9.3 NO. 12 BROOKMAN STREET (LOTS: 69 AND 90; PLAN: 4576) - PROPOSED ALTERATIONS AND ADDITIONS TO SINGLE HOUSE

RECOMMENDATION:

That Council, in accordance with the provisions of the City of Vincent Local Planning Scheme No. 2 and the Metropolitan Region Scheme, REFUSES the application for Alterations and Additions to Single House at No. 12 (Lots: 69 and 90; P: 4576) Brookman Street, Perth in accordance with the plans shown in Attachment 2 with the associated determination advice notes in Attachment 11, for the following reasons:

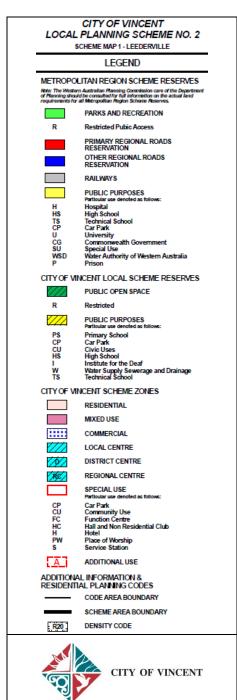
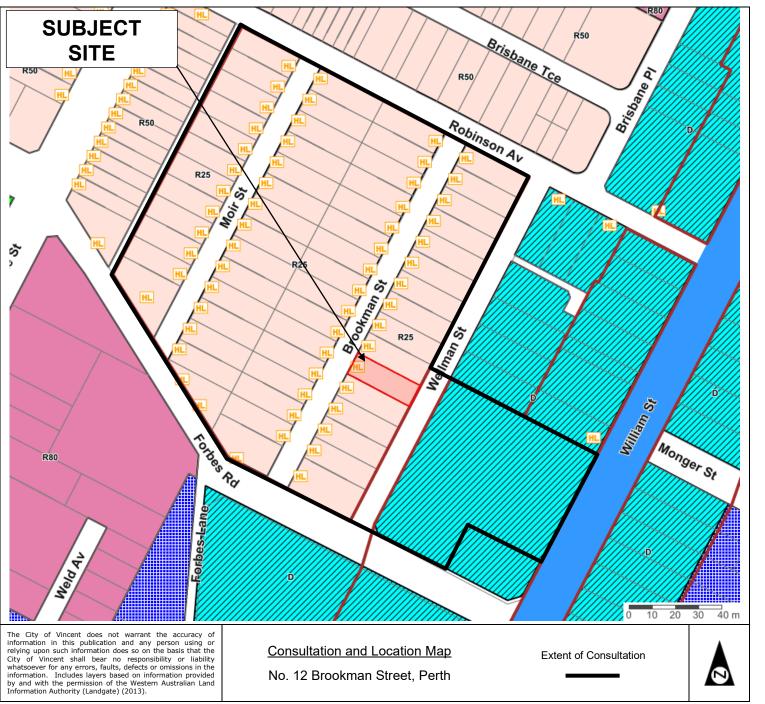
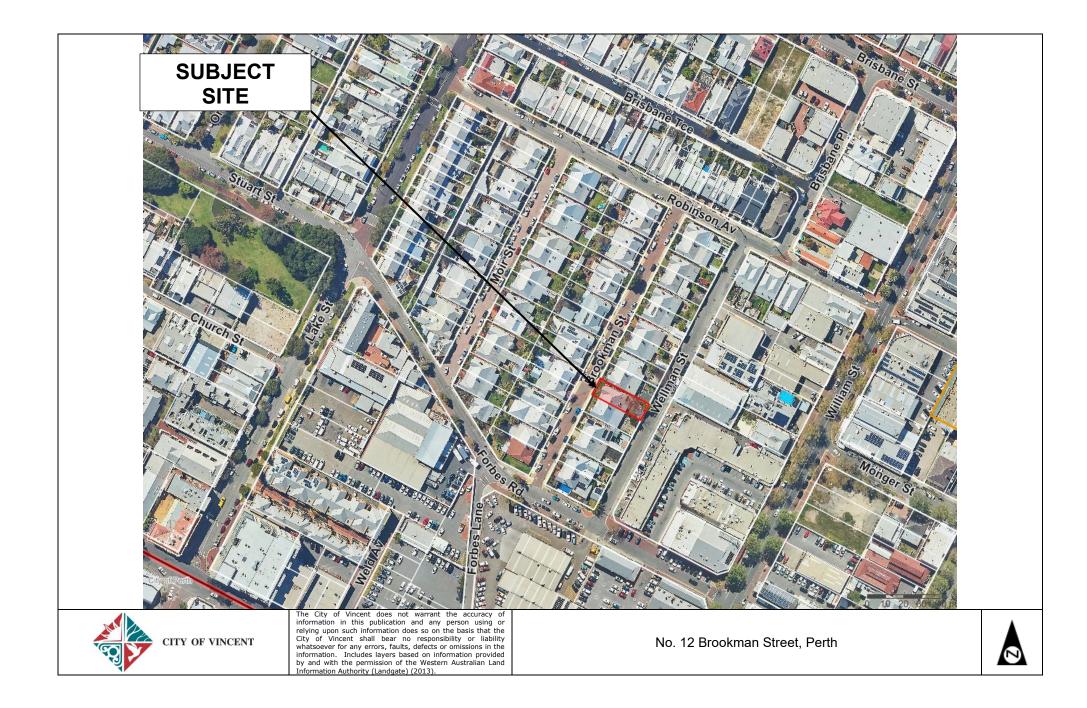
A site inspection by Administration as part of this assessment noted the presence of rendered masonry walls to the south west and south east elevations of the rear water closet. The north west and north east elevations consisted of new masonry and stud-framed walls respectively. The above leads Administration to conclude that while the water closet has been modified, there is original brickwork remaining.

Officers from the HCWA and the DRP Member advised that given the water closets are not specifically mentioned in the Statement of Significance and the extent of the modification to the existing structure, the demolition of the rear water closet was acceptable.

The Brookman/Moir Guidelines state that demolition of water closets will only be considered in exceptional circumstances. The water closet remains in its original location on site and the continued presence of the rear water closet represents an original feature of the subdivision of the Precinct allows for an understanding of the history of the place. The applicant has not provided sufficient analysis of the condition of the existing water closet to confirm that its removal would not adversely impact the heritage fabric of the place.
